UNITED STATES  
NUCLEAR REGULATORY COMMISSION  
WASHINGTON, D. C. 20555  
July 11, 1985

Docket No. 50-416

LICENSEE: Mississippi Power and Light Company  
FACILITY: Grand Gulf Unit 1  
SUBJECT: SUMMARY OF JUNE 19, 1985 MEETING REGARDING CONTAINMENT  
SUPPRESSION POOL SWELL THROUGH ENCROACHED AREAS

The purpose of the meeting was to discuss resolution of concerns regarding containment suppression pool swell through encroached areas. Enclosure 1 is a list of attendees. Enclosure 2 is a copy of slides and/or handouts prepared by an NRC consultant used in the meeting. Enclosure 3 is a copy of slides prepared by General Electric (GE) used in the meeting.

Fig. 12:  $1/10$ -scale simulation of Grand Gulf encroachment,  
 $t = 0.69$  s (full scale) after "vent clearing"  
(Frame 20).

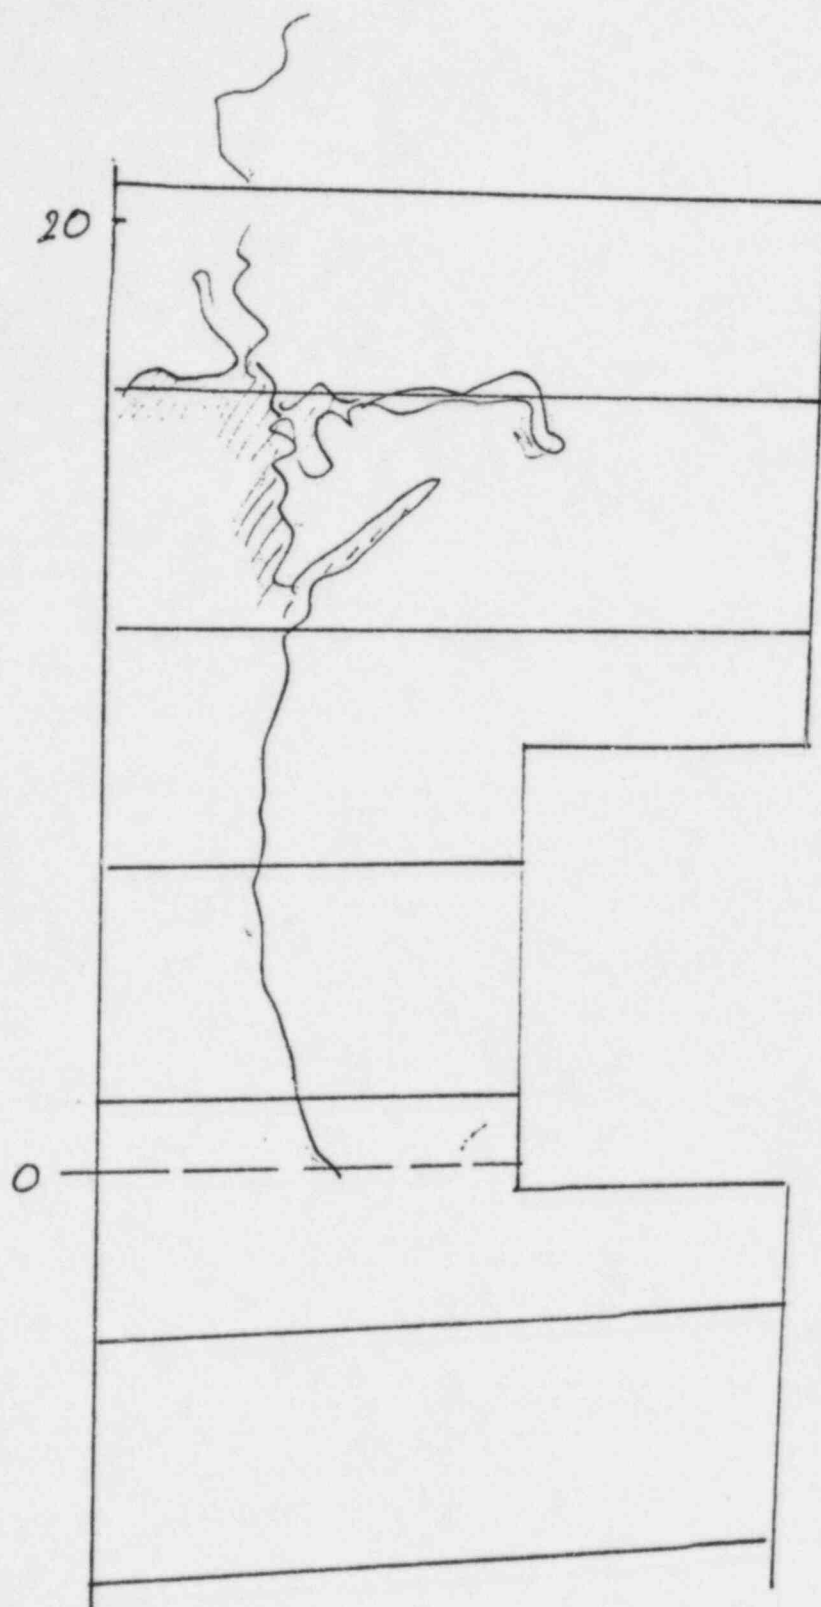
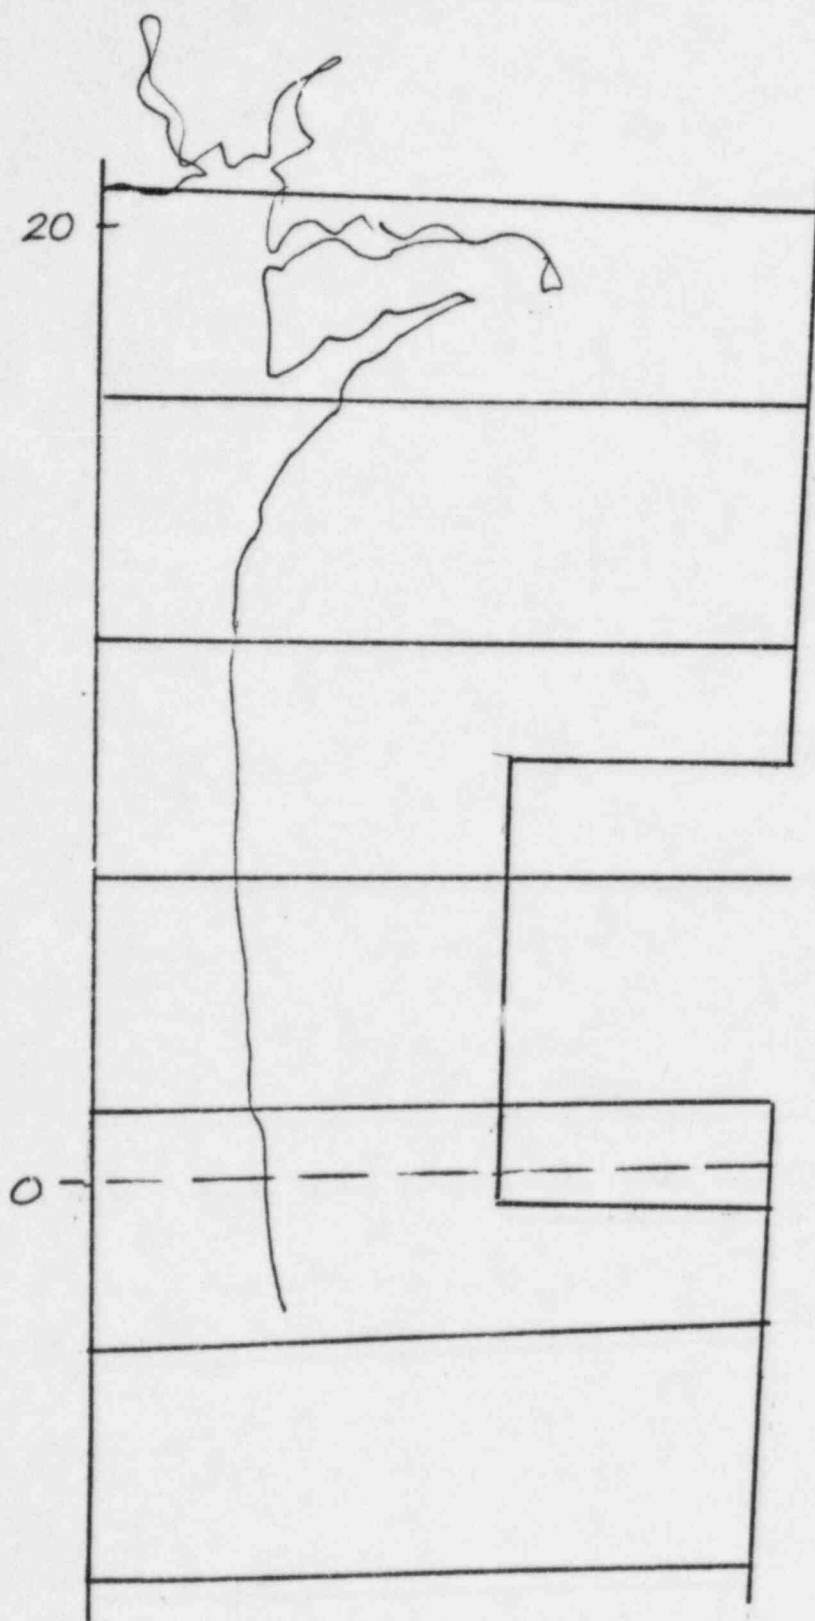
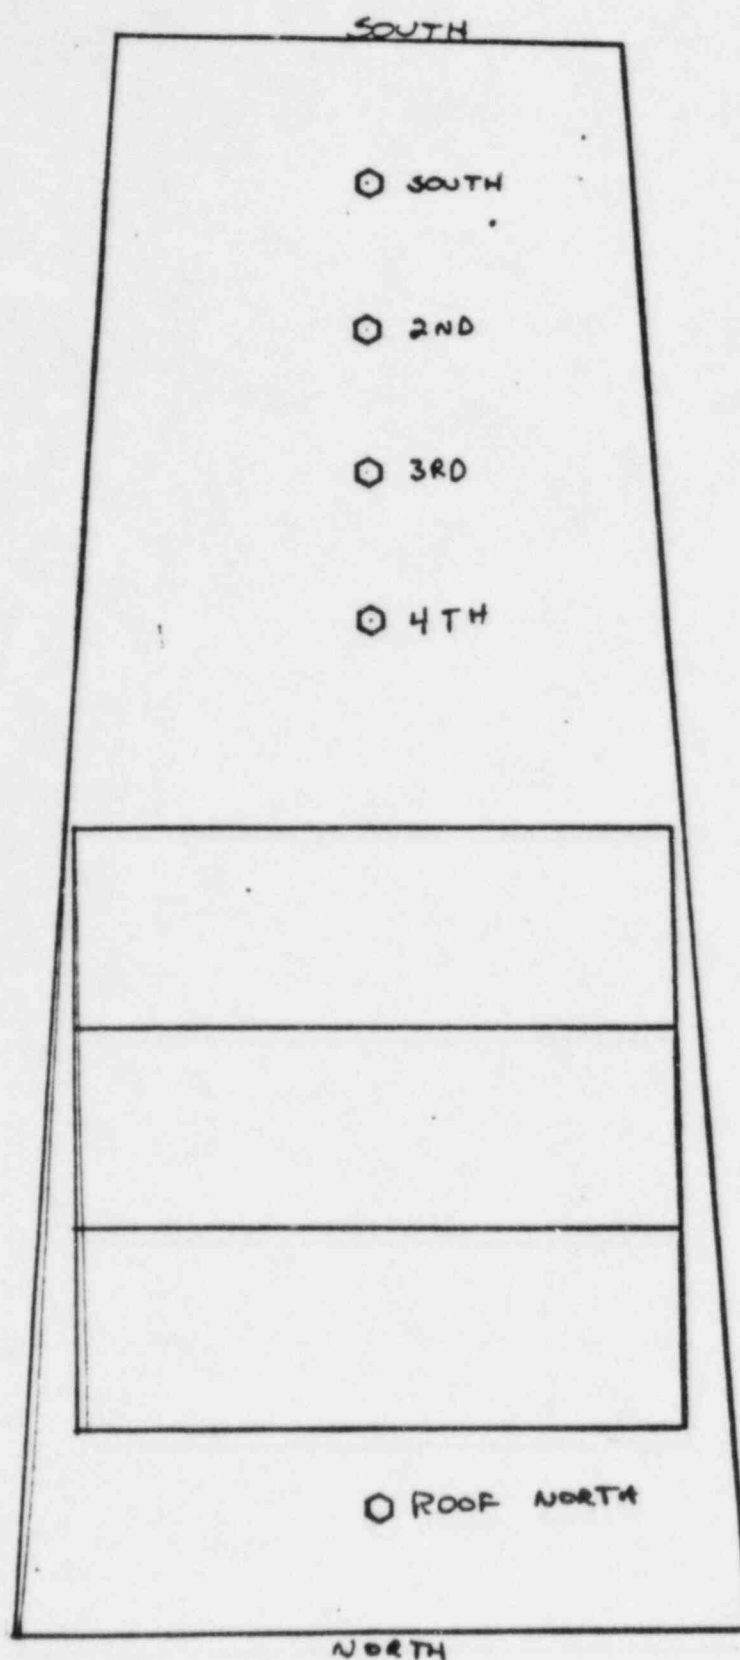
- Stream velocities were lower than in unencroached pool, and widths no greater (of solid water stream).
- Although "lips" made some of the impacting regions broader than in the unencroached pool, the  $1/\sqrt{3}$ -scale data shows that even local pressures in impacted region are below mean pressure specified in LD.
- Hence, existing clean-pool LD should bound encroached pool cases.

<u>At contain't wall (a min. elevation)</u>	<u>At pt. of max. elevation</u>	<u>Average</u>
PERRY	51	57	54
GRAND GULF	35	35	35
CLINTON I	47	47	47
CLINTON II	66	41	54
CLEAN POOL	57	66	60(?)

FIGURE I-1. TEST TANK AND SIMULATED GRAND GULF ENCROACHMENT

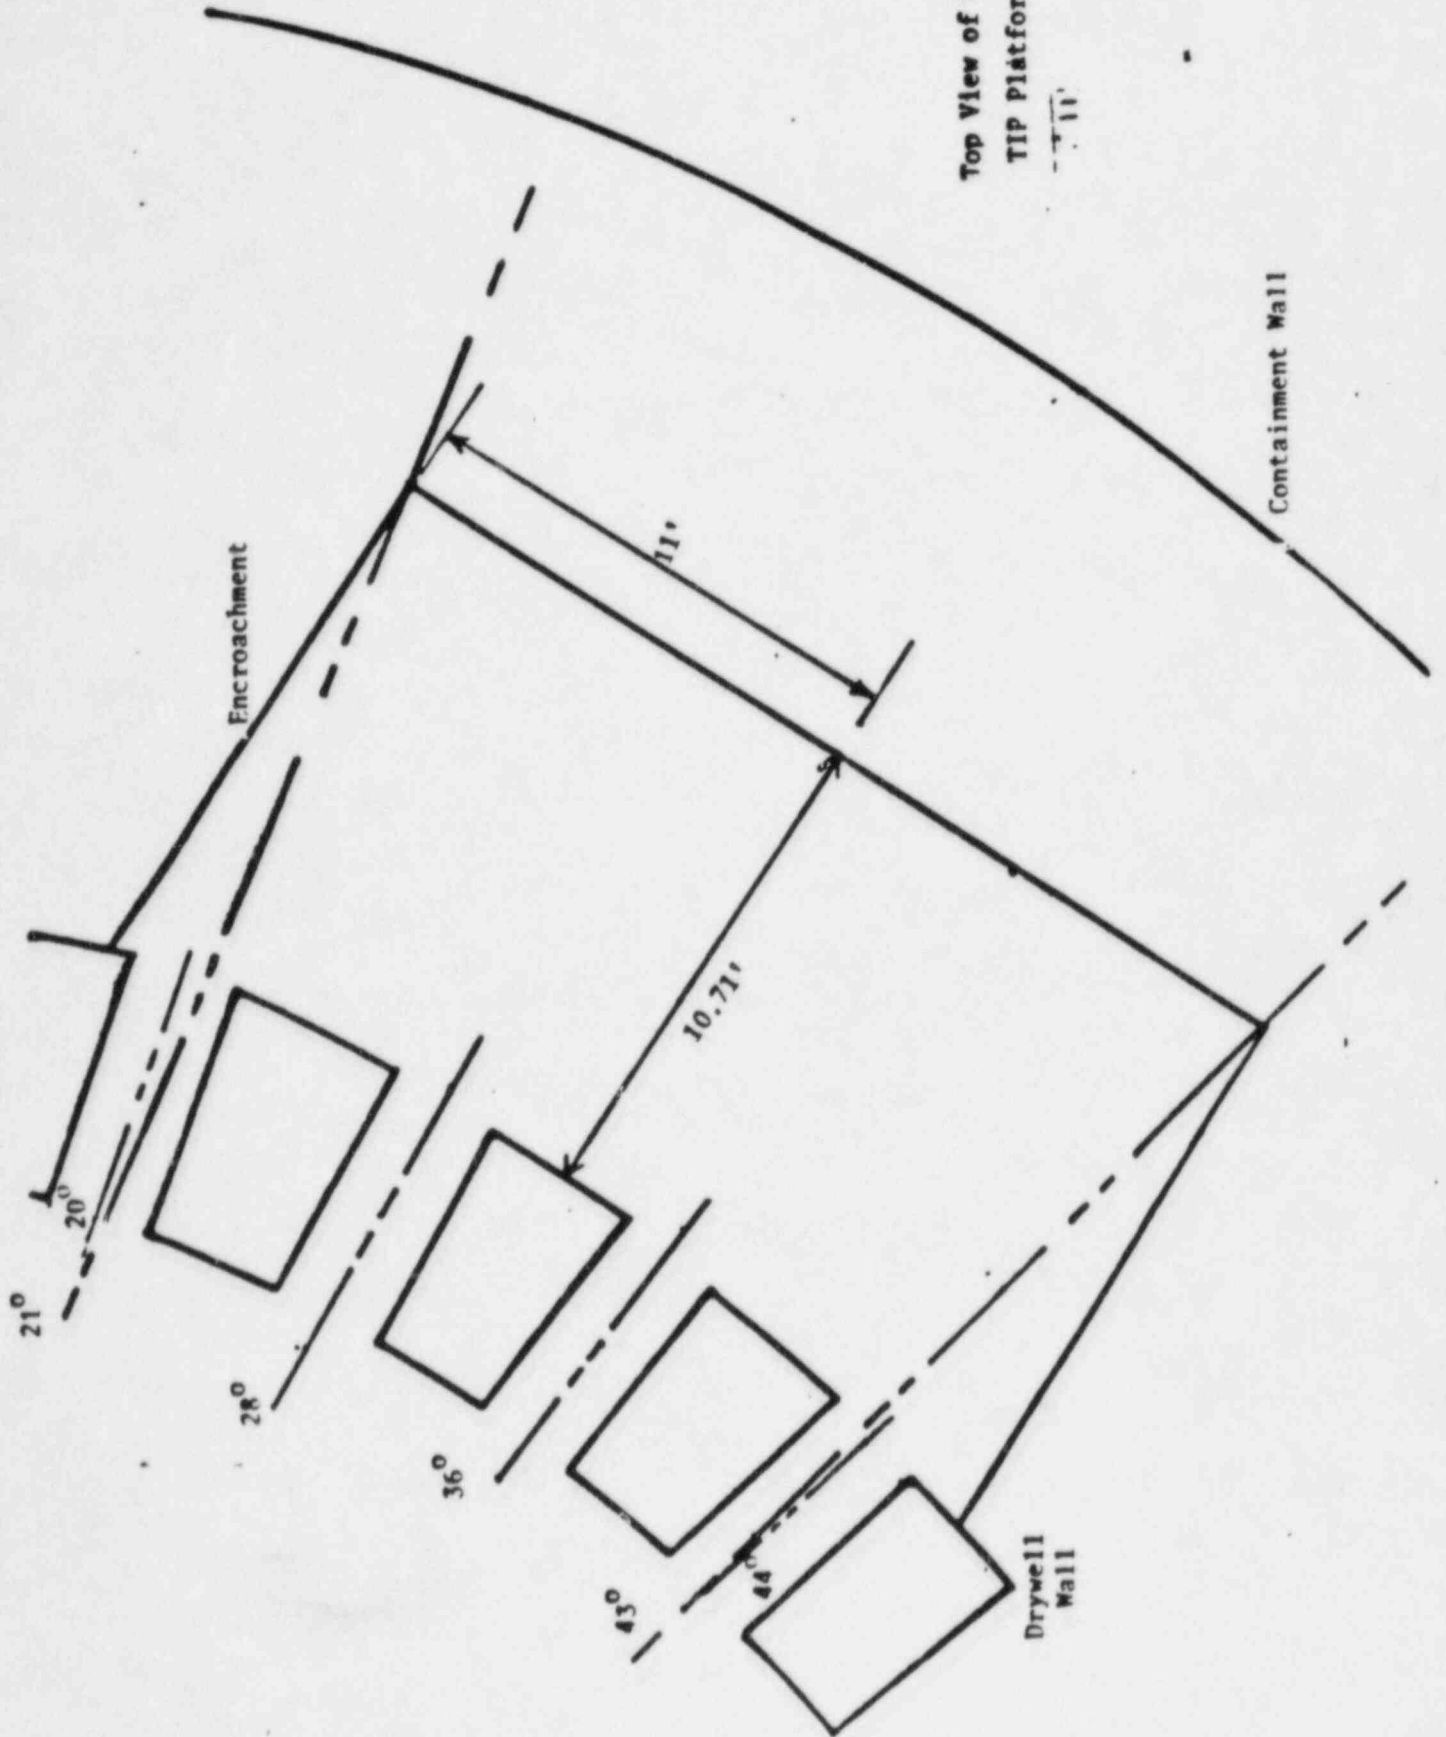
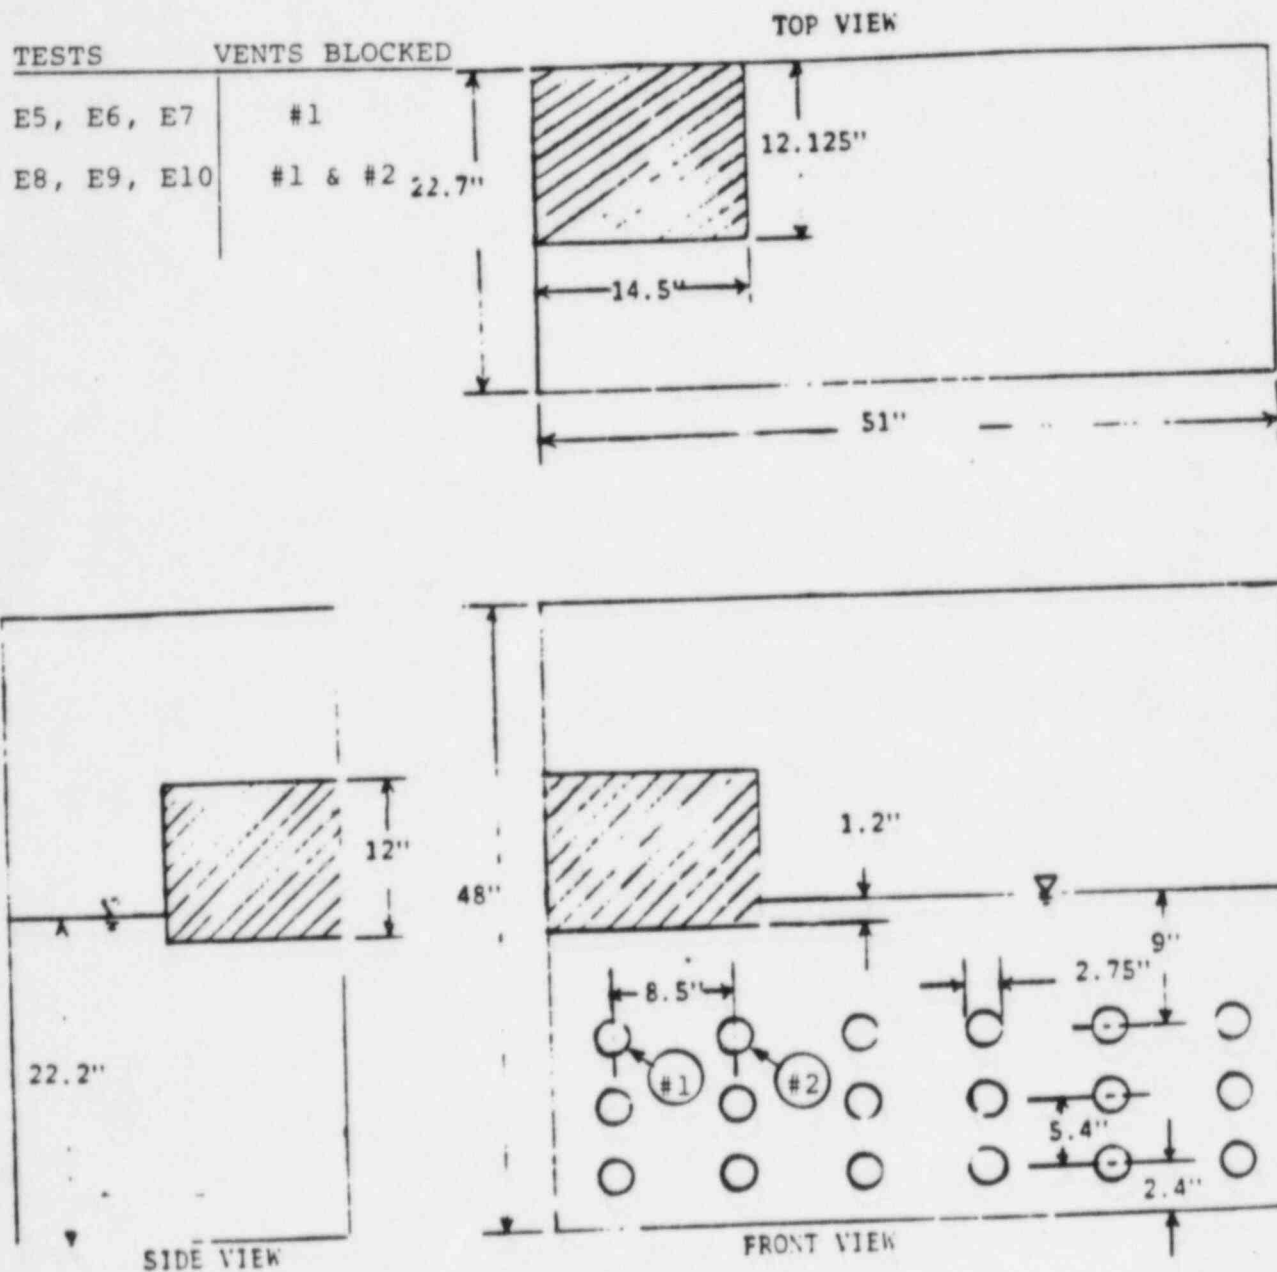
- o SAME HARDWARE AS GGNS PLANT UNIQUE TESTS
  - 1/10 SCALE RECTANGULAR TEST TANK
  - GGNS TIP PLATFORM
  - BLOCKED TOP VENT(S) UNDER ENCROACHMENT
- o TWO CONFIGURATIONS TESTED
  - ONE VENT BLOCKED
  - TWO VENTS BLOCKED
- o TEST MATRIX
  - THREE REPEAT TESTS WITH EACH CONFIGURATION
  - SAME BLOWDOWN CONDITIONS AS GGNS BASE TESTS

- o ONE VENT BLOCKED (EQUIVALENT TO TWO IN PLANT)
  - FROTH-LIKE IMPACT AT HCU FLOOR IN VICINITY OF ENCROACHMENT
  - NO EFFECT ON  $P_{DW}$
  - CLEAN POOL RESPONSE UNCHANGED
- o TWO VENTS BLOCKED (EQUIVALENT TO FOUR IN PLANT)
  - NEGLECTIBLE IMPACT AT HCU FLOOR IN VICINITY OF ENCROACHMENT
  - SMALL EFFECT ON  $P_{DW}$
  - CLEAN POOL RESPONSE UNCHANGED
